THE NEW YORK PUBLIC LIBRARY
MIDTOWN CAMPUS RENOVATION
STEPHEN A. SCHWARZMAN BUILDING

New York City Landmarks Commission
FOLLOW-UP SUBMISSION | March 5, 2019

Commissioner Comments from 2/19:

Existing & Proposed Site Lighting

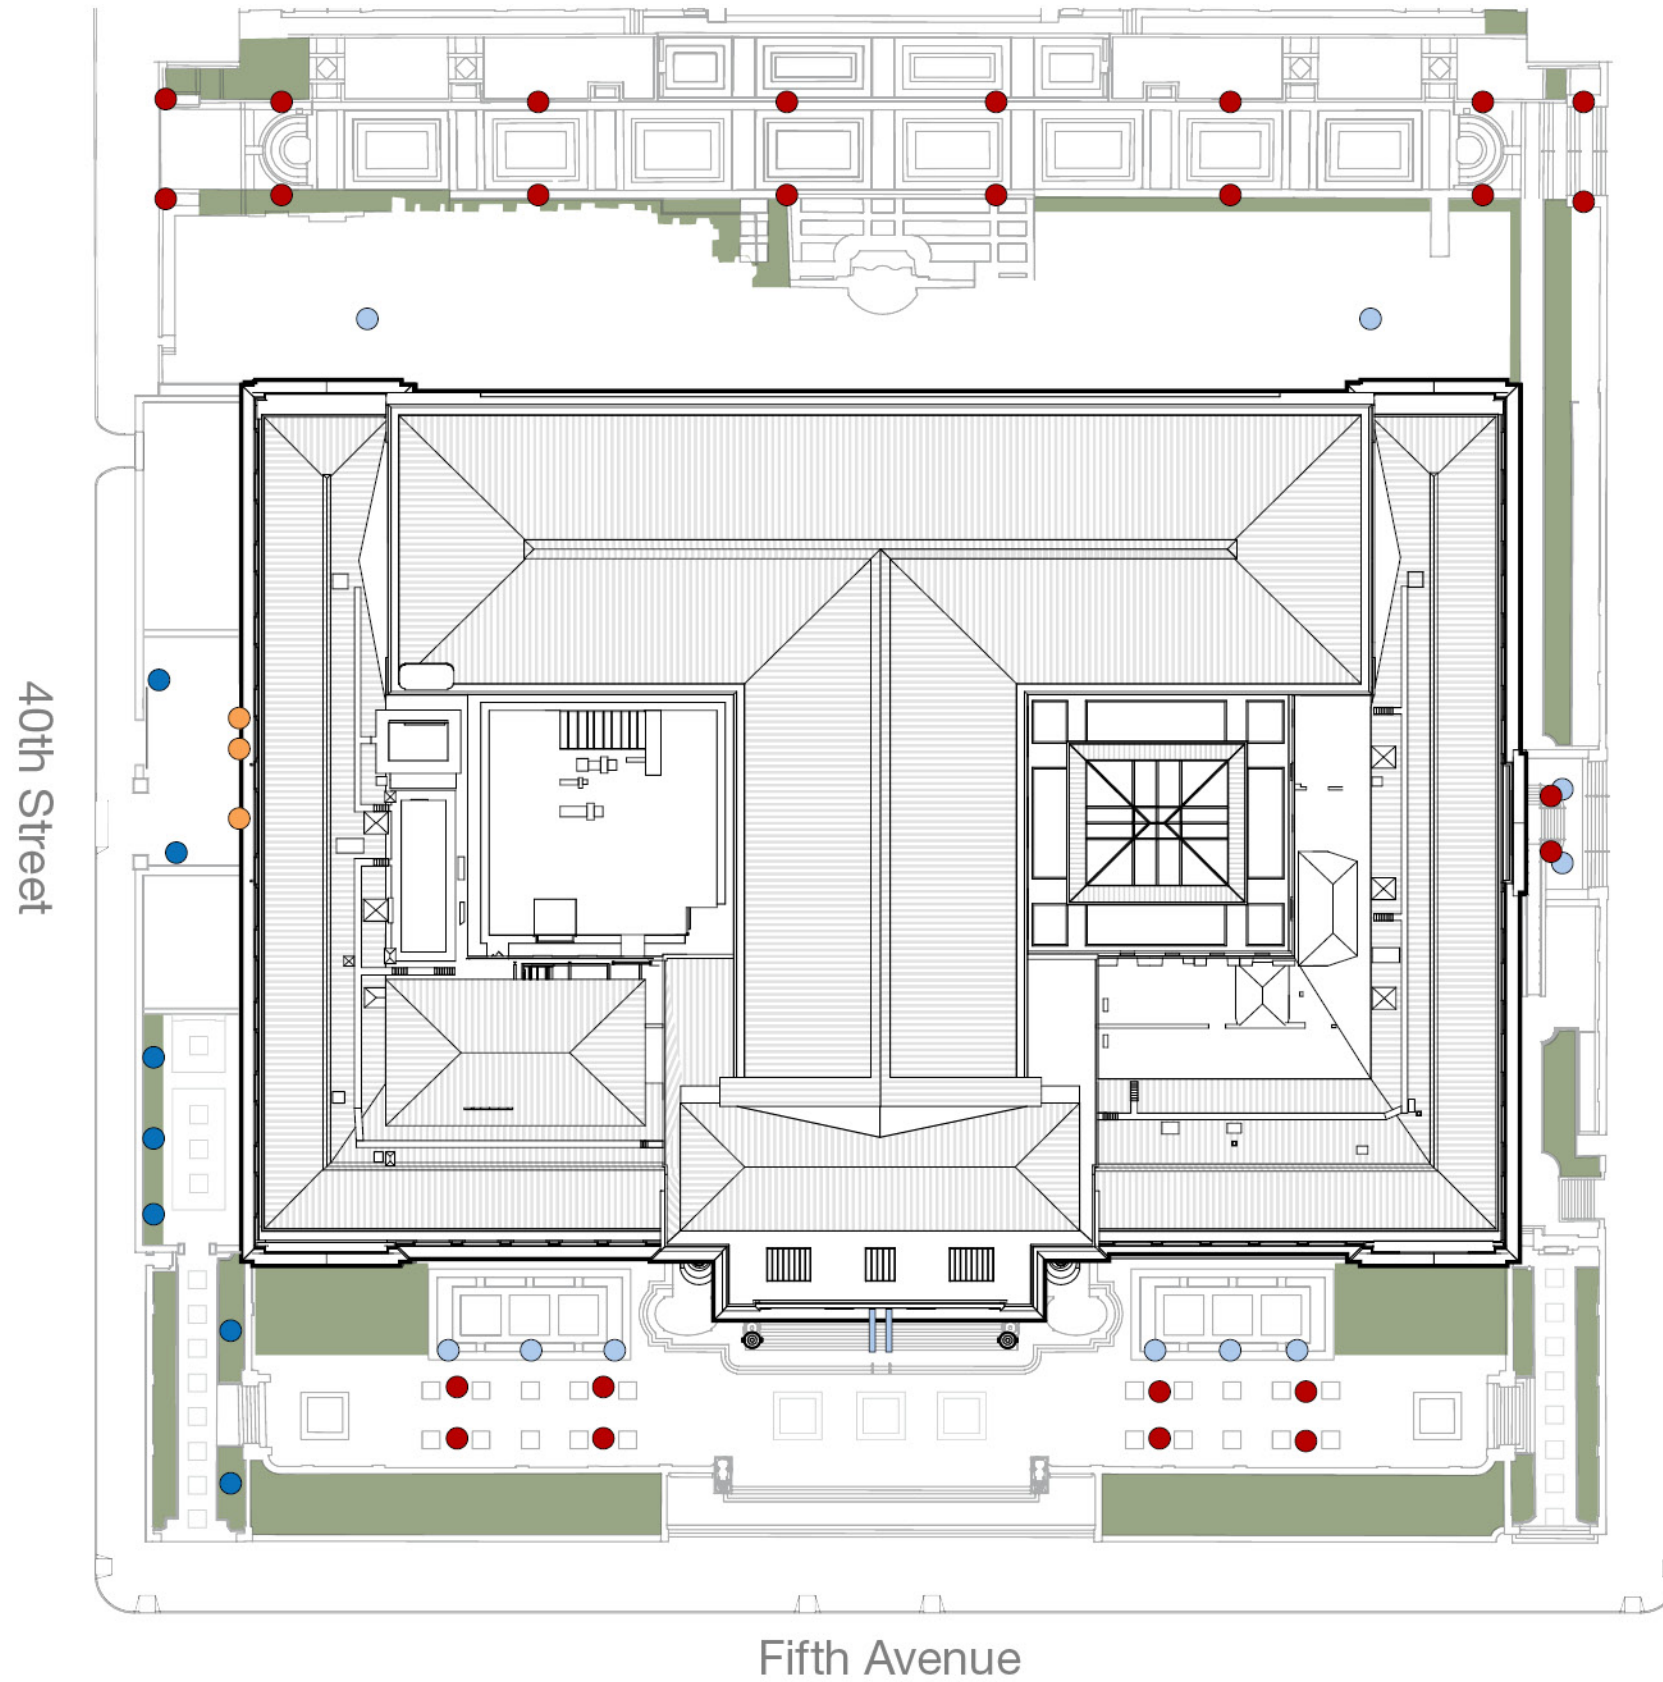
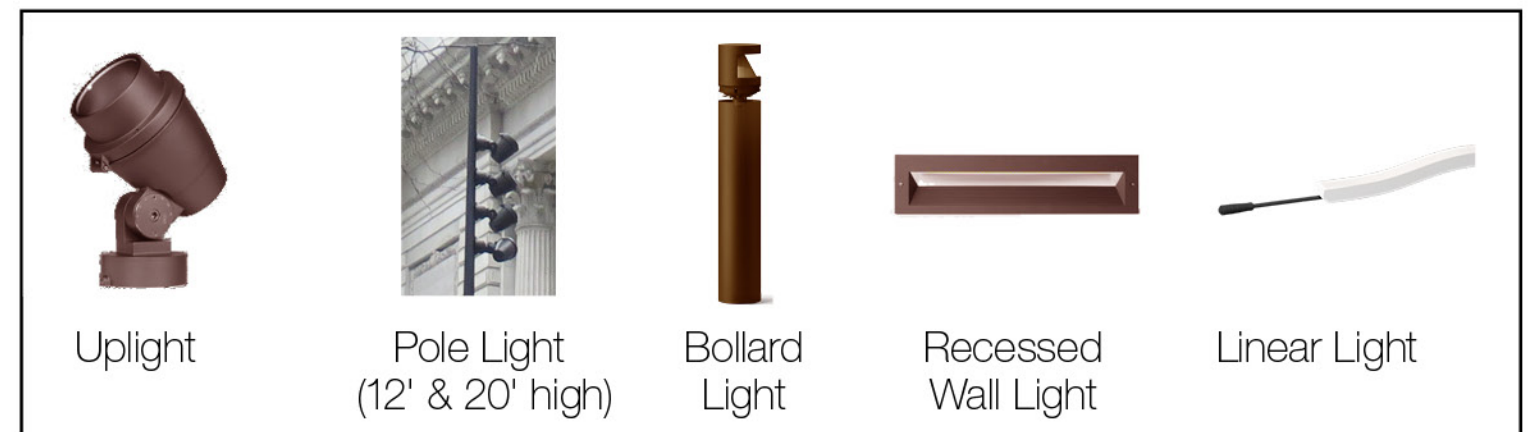
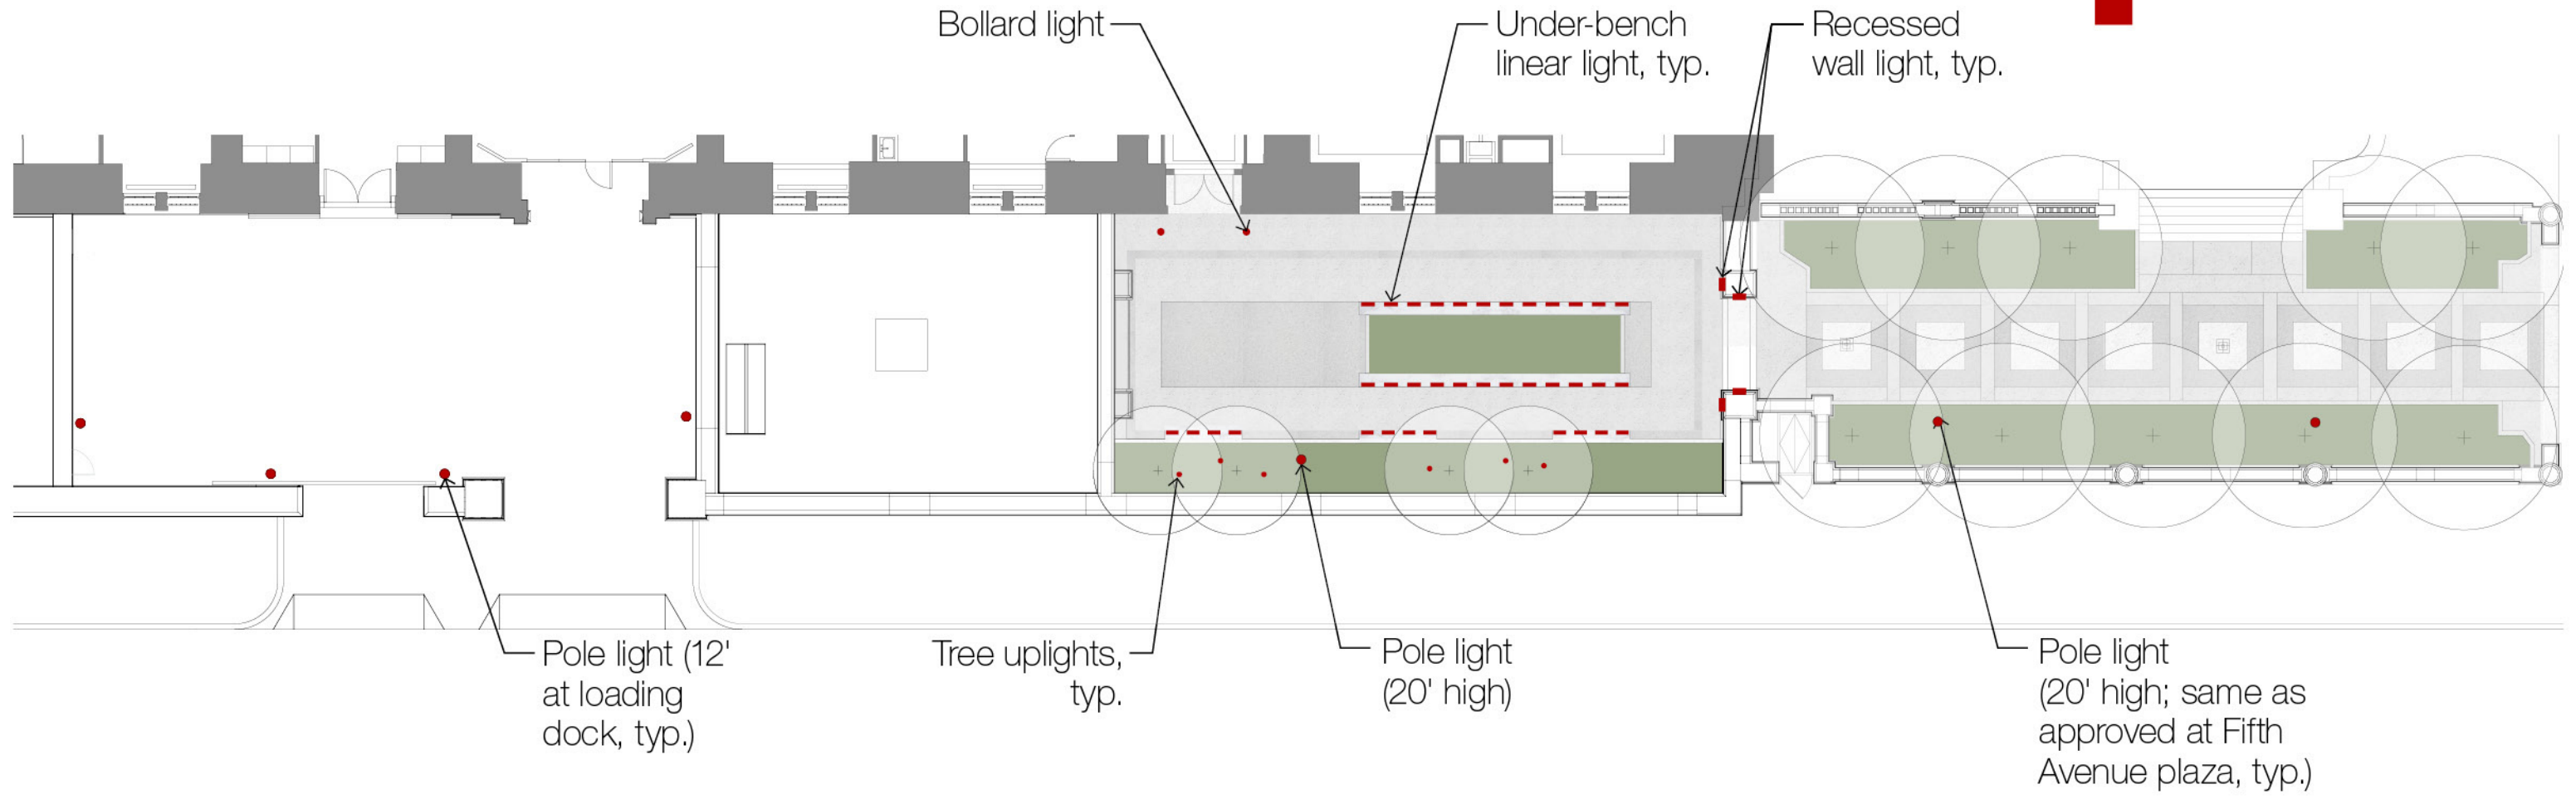
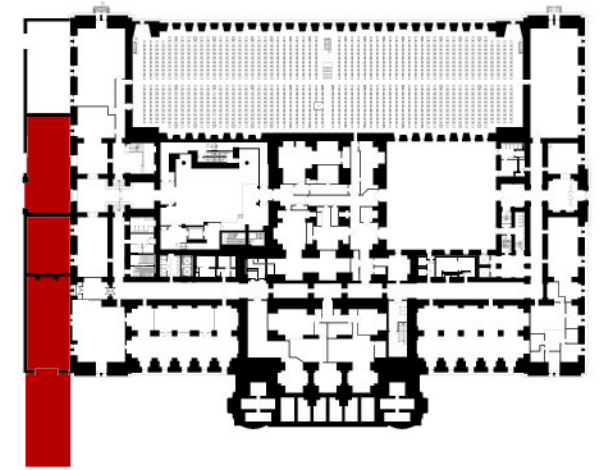
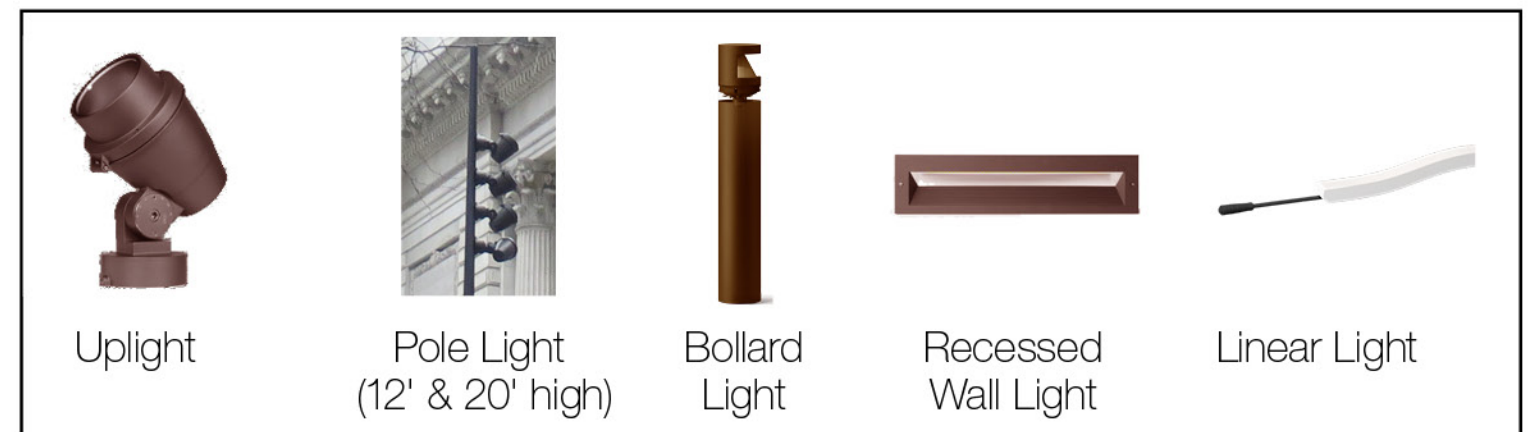
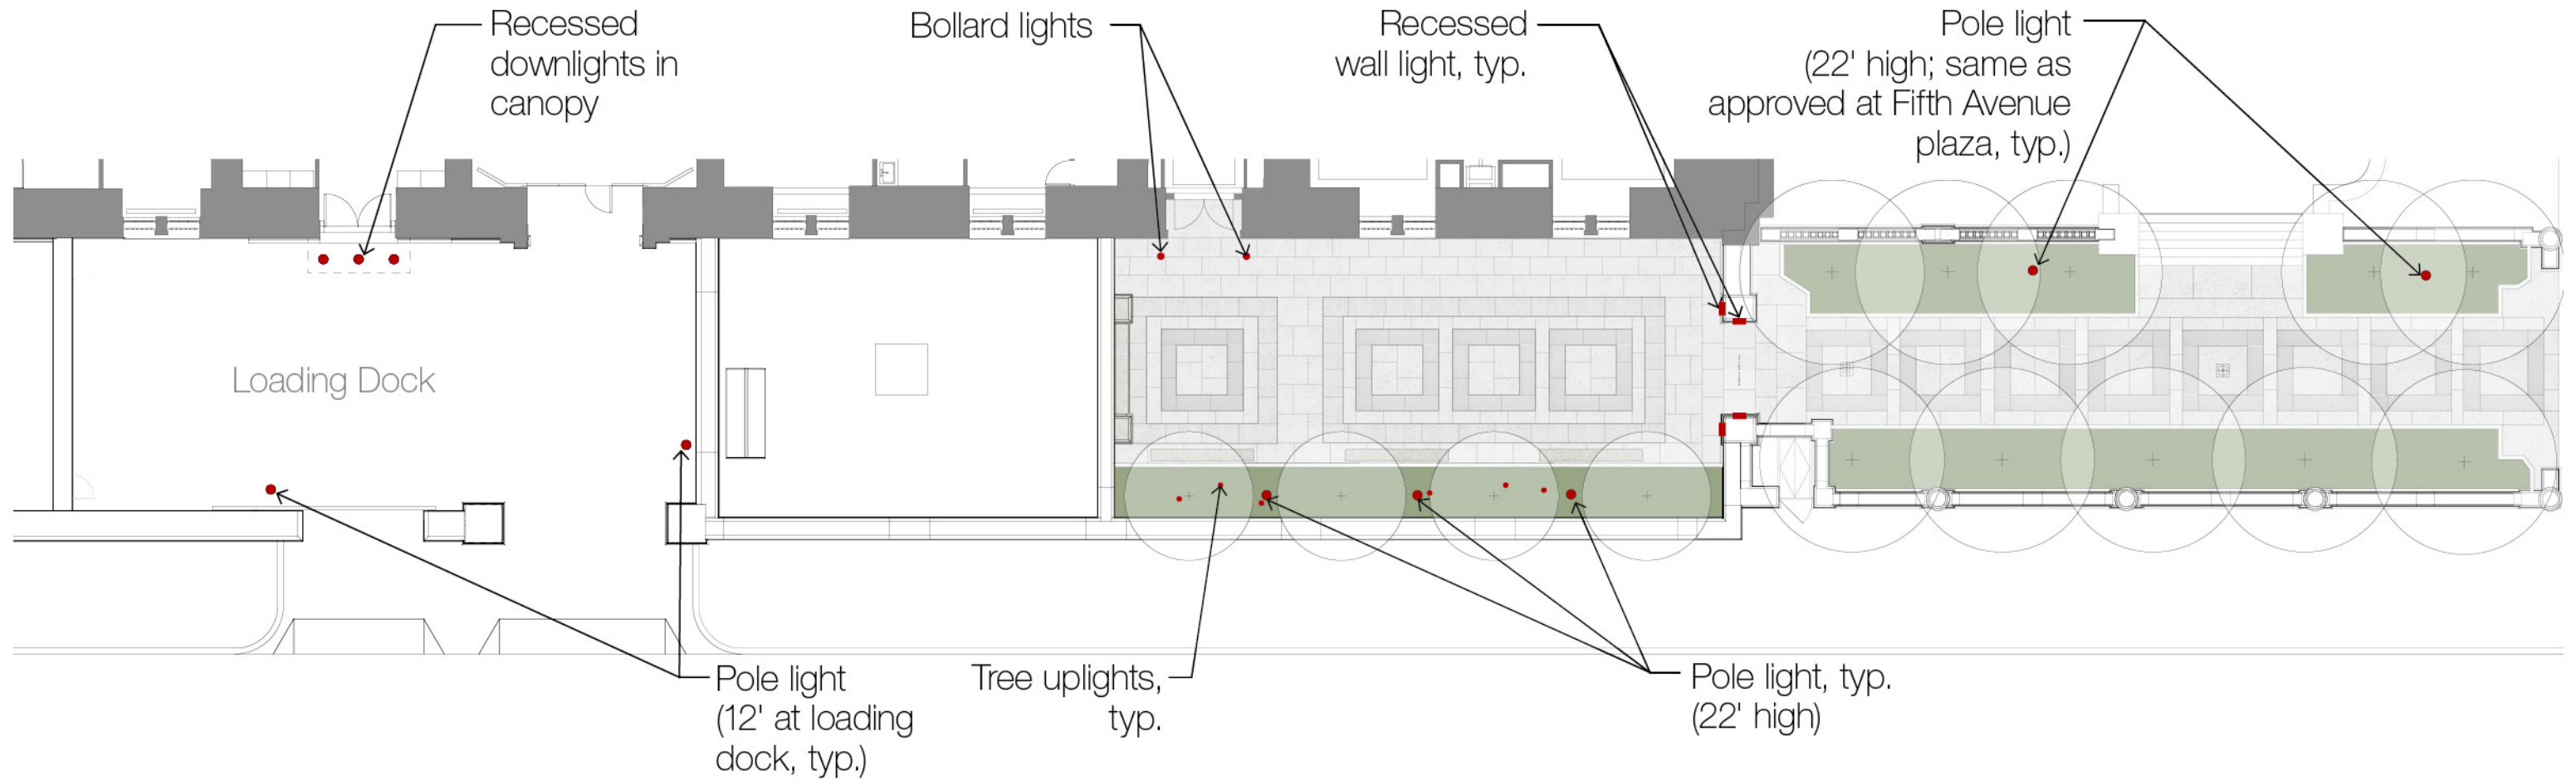
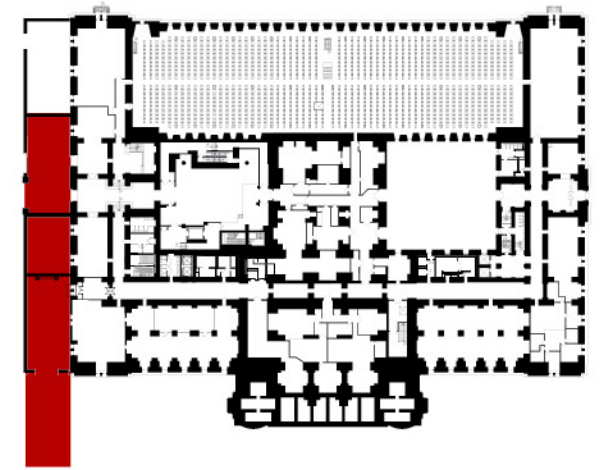
- Reconsider planter & paving design at proposed 40th Street Terrace
- Review lighting design at loading dock, specifically the number of poles

- Revised location of Fifth Avenue Plaza proposed light poles

- Existing original pole lighting
- Non-original lighting
- Non-original surface-mounted lighting to be removed
- Proposed non-original pole lighting
